RANGER AR-3300; UPDATE

Tech. Bulletin #1... Re: Vol. 25 SCB.

Schematic of change is below:

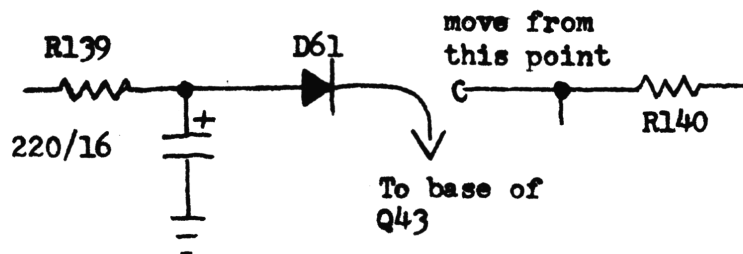
Again; this is the modification on all units below serial numbers 86020800 only.

1. Remove R139, change to 4.7K ohm 1/4W 10% resistor.
2. Lift cathode side of D61 (banded end); replace cathode to base of Q43.
3. Add a 220Mfd/16VDC electrolytic capacitor from junction of R139/D61 to D.C. ground. (+ to junction)...

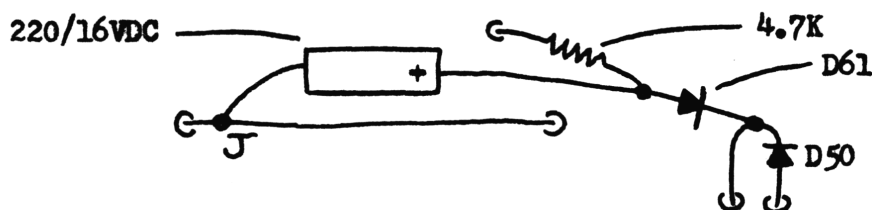
Editor Note: I have found it next to impossible to modify units by placing the capacitor on etch side of chassis.

Recommend that it be modified as below. Utilized on A/N: 86020436 with no problems.

1. Remove D61 carefully; save diode.
2. Remove R139-discard; cleanout left hole (viewed from component side).
3. The solid buss jumper directly below R139 hole is D.C. ground potential. This will be used as capacitor ground point.
4. Wire all components as shown, "FIT" all parts before soldering.
